CITY OF MADISON

PLAN OF PROPOSED IMPROVEMENT

REVISION 1 - 9/30/2025
SHEETS REPLACED: P1,U1,L1

633-711 W BADGER ROAD CSM

MARK	REVISION	DATE	BY
15319	15319	9/30/2025 10:16 AM	P-1

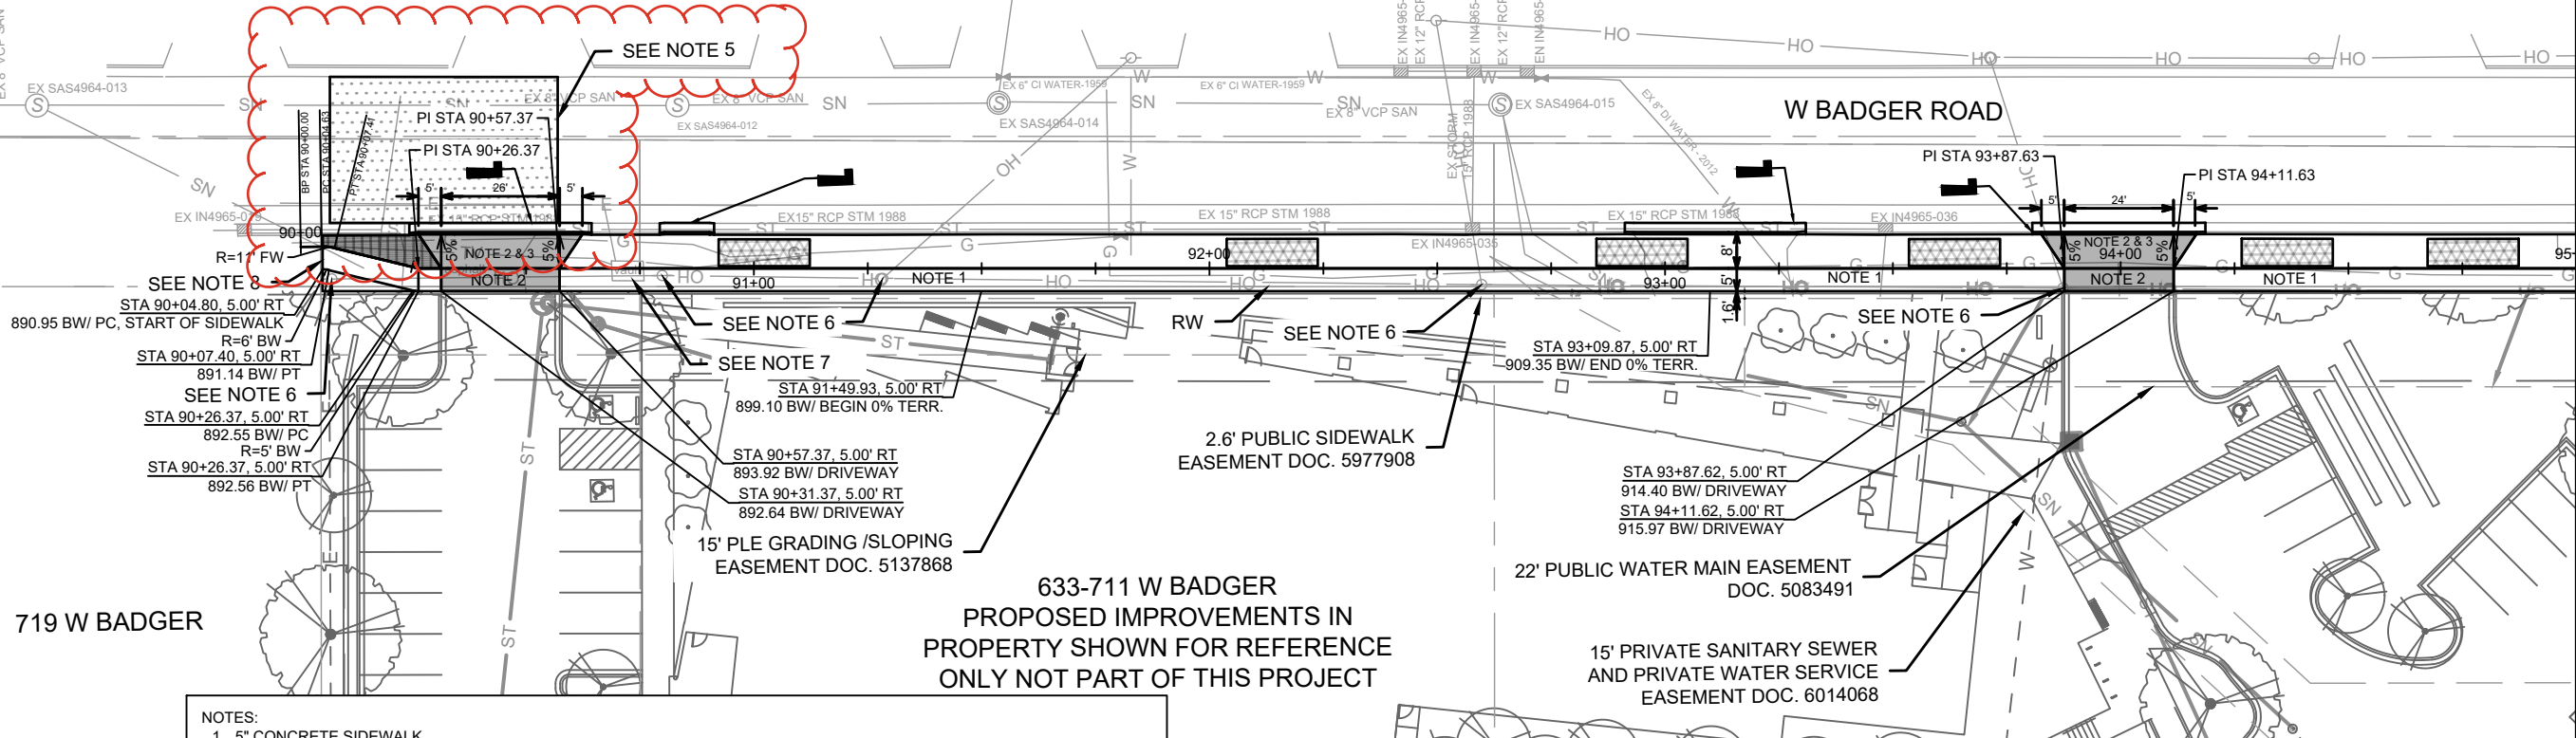
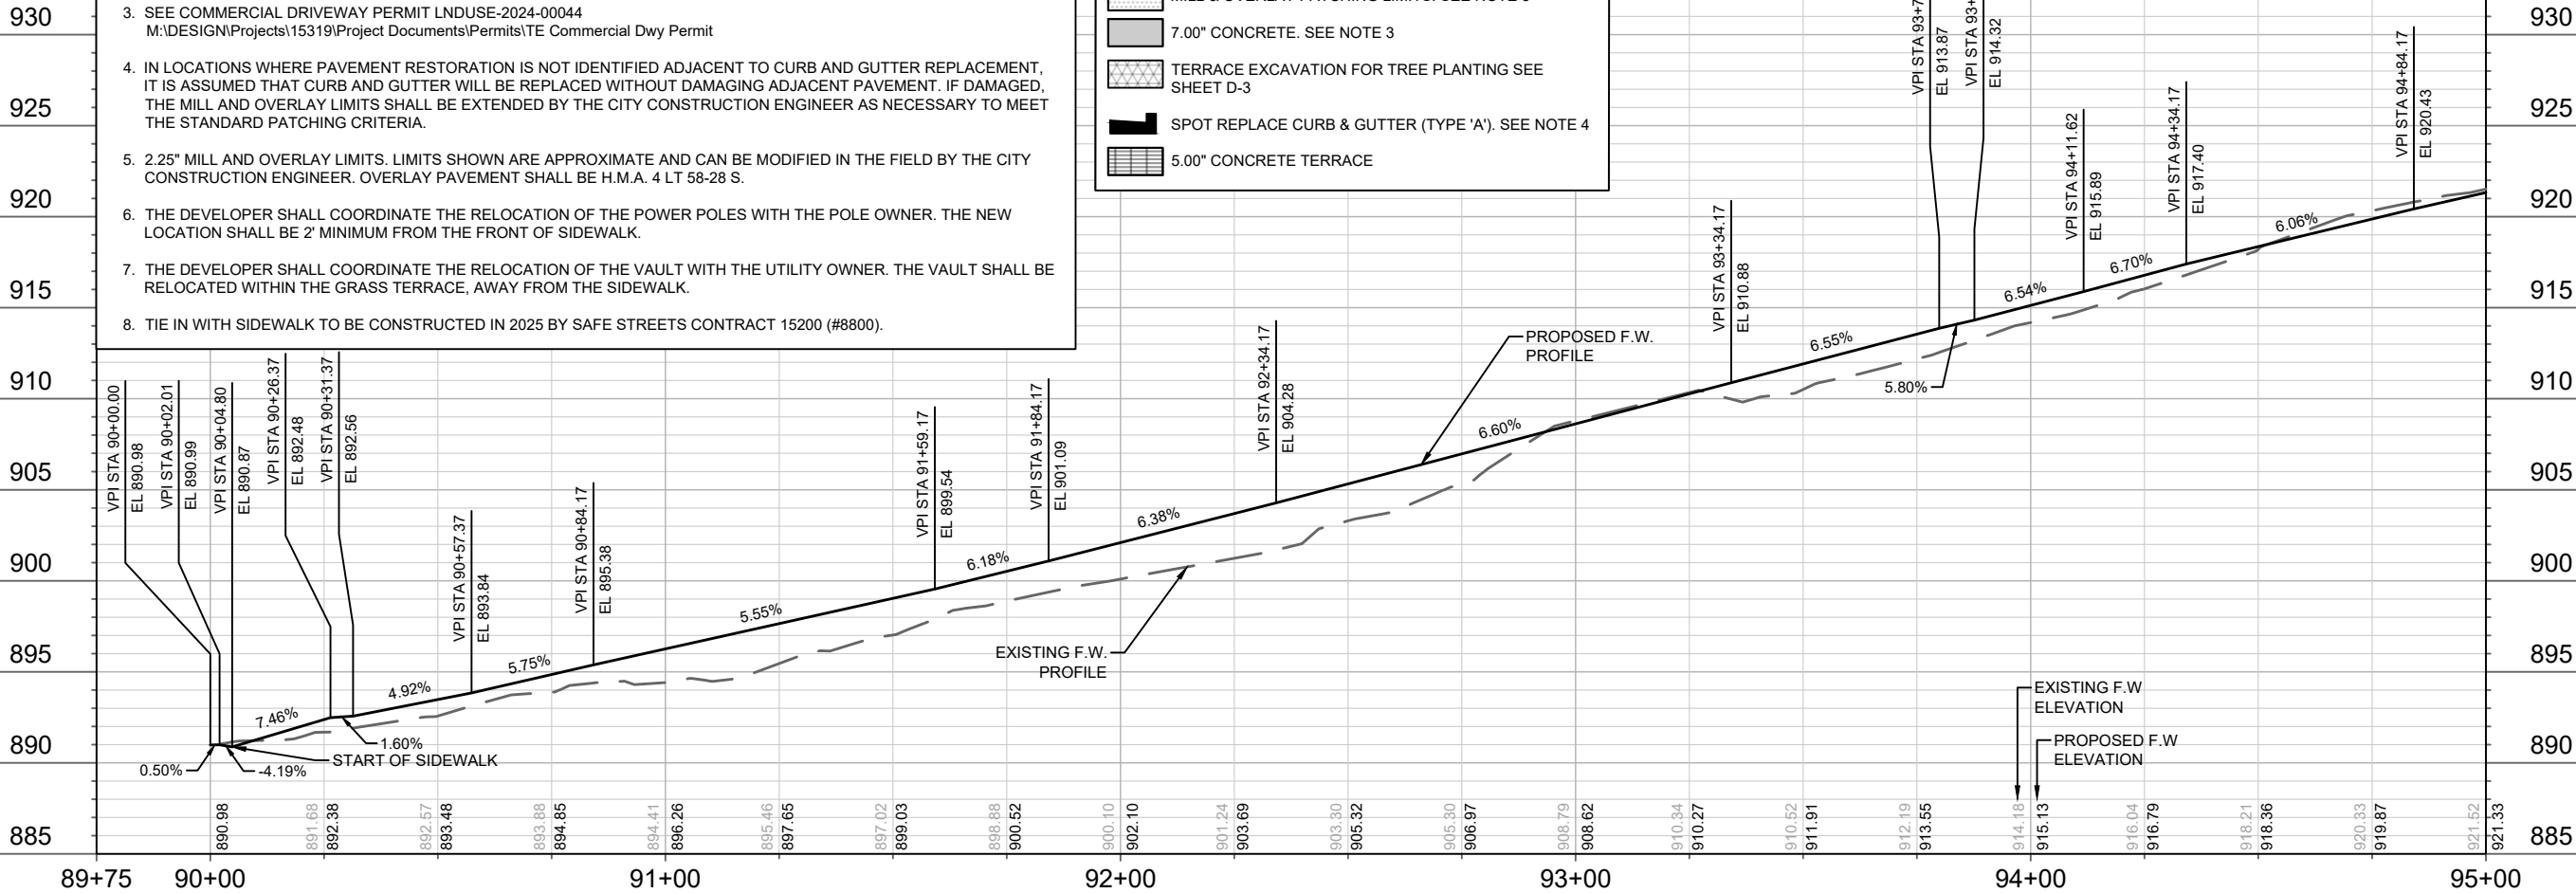
9/30/2025 NGV REV 1:
UPDATES TO MILL AND OVERLAY LIMITS
AND ADDED CONCRETE TERRACE

15319
P-2

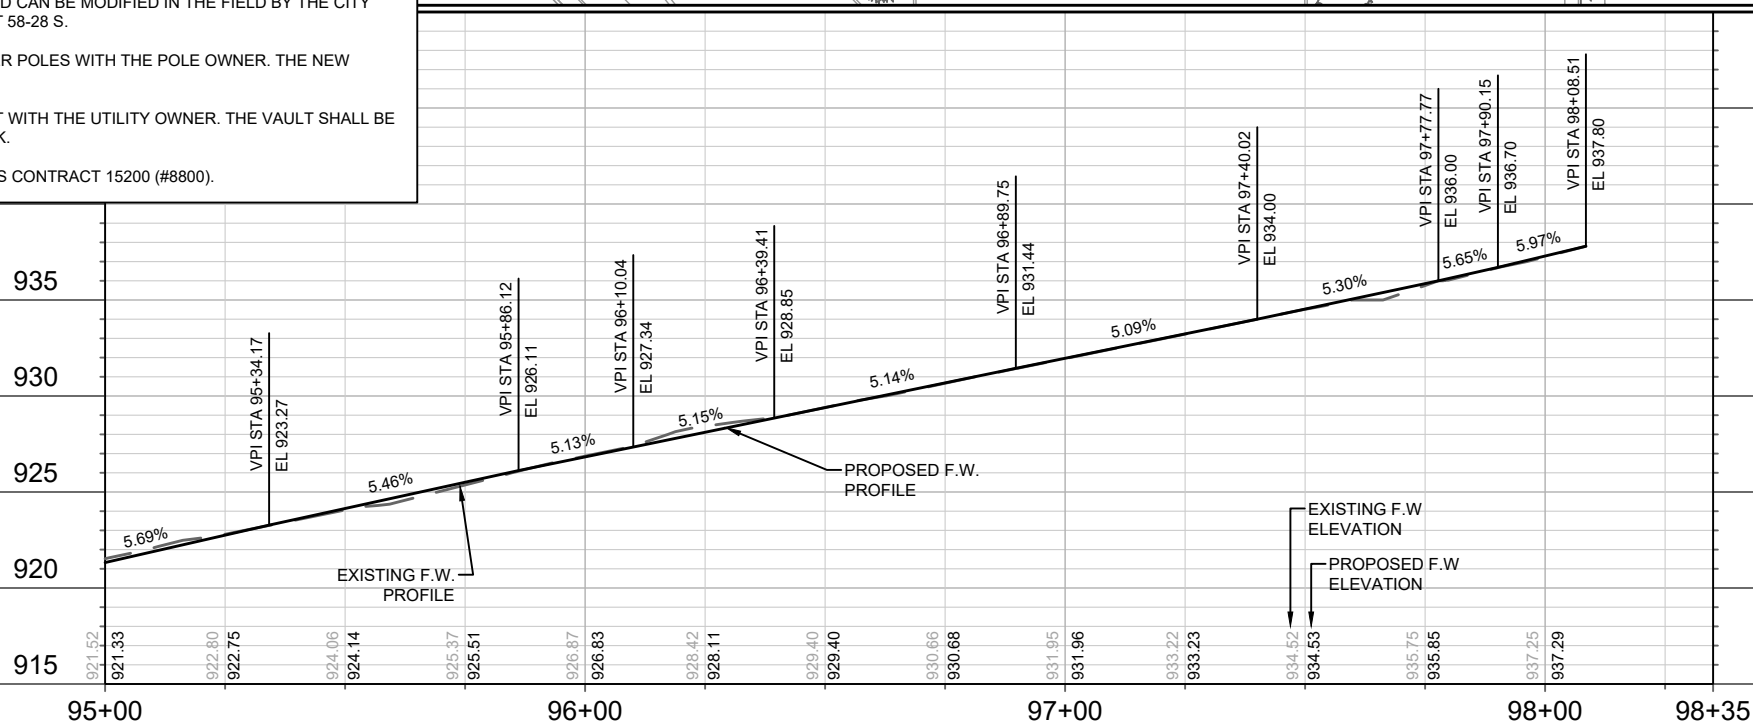
10/30/2025 NGV REV 2:
UPDATE SIDEWALK DIMENSIONS

UTILITY PLAN		15319		MADISON, WI		CONTRACT NO: 9533	
633-711 W BADGER ROAD CSM		15319		MADISON, WI		CONTRACT NO: 9533	
M:\DESIGN\Projects\15319\CAD\Sewers\15319SWR-PnP.dwg		15319		MADISON, WI		CONTRACT NO: 9533	
15319		15319		MADISON, WI		CONTRACT NO: 9533	
U-1		U-1		MADISON, WI		CONTRACT NO: 9533

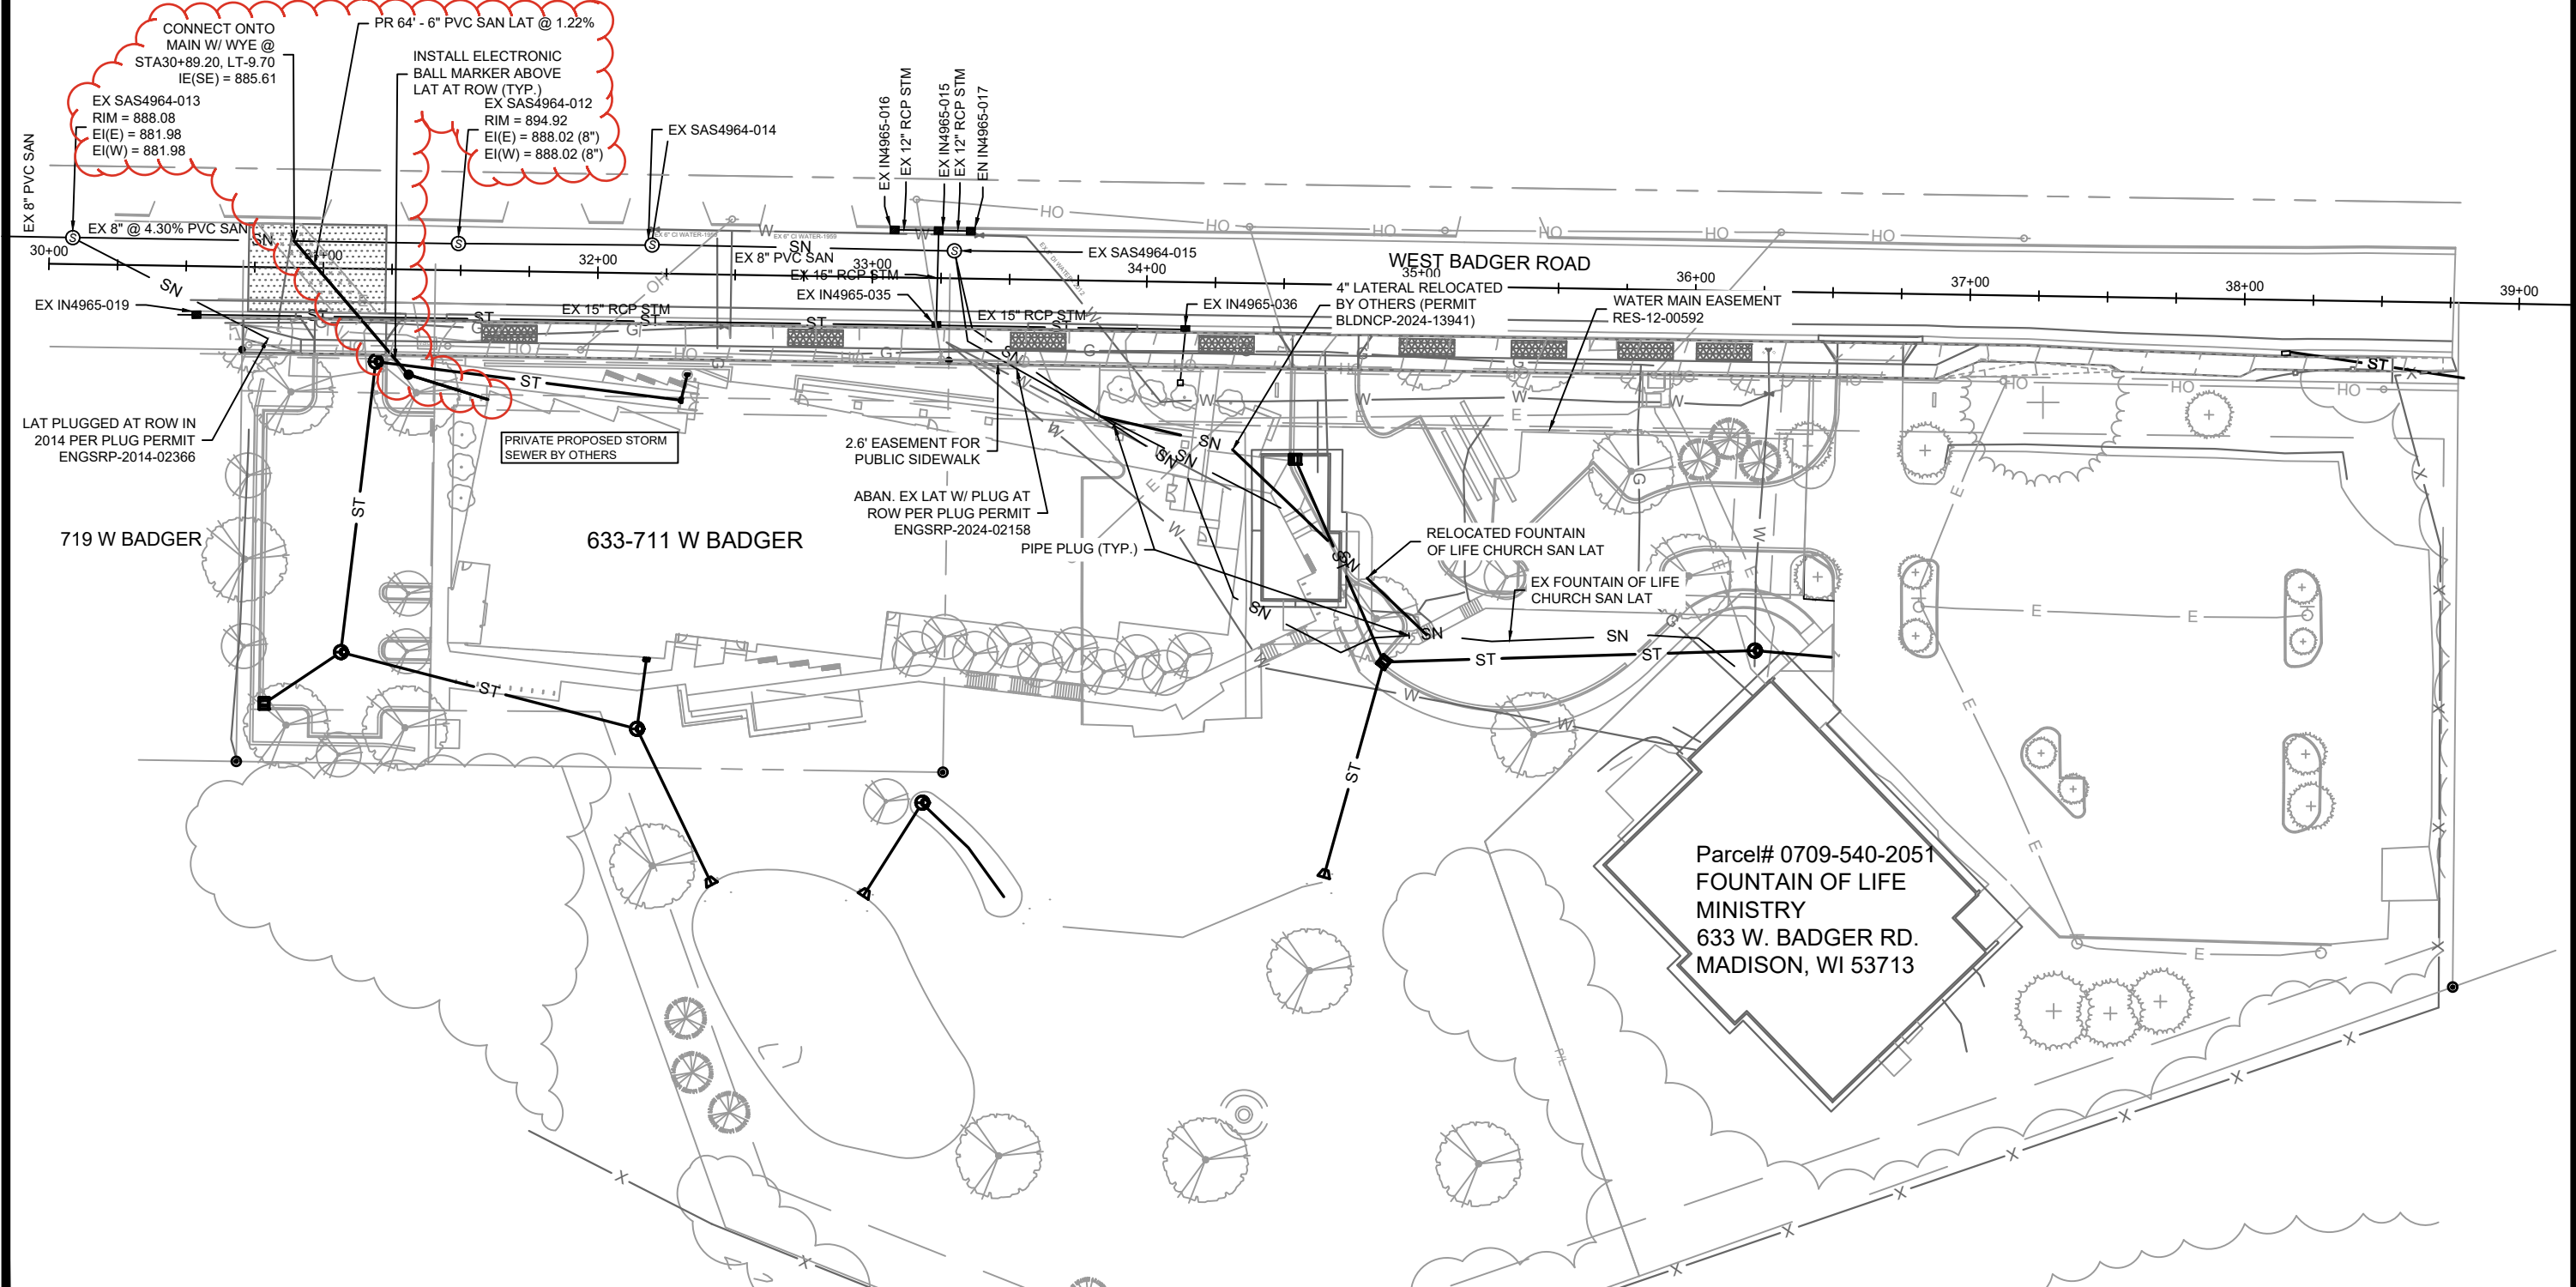
9/30/2025 TAC REV 1: UPDATES TO
PVT LATERAL CONNECTION
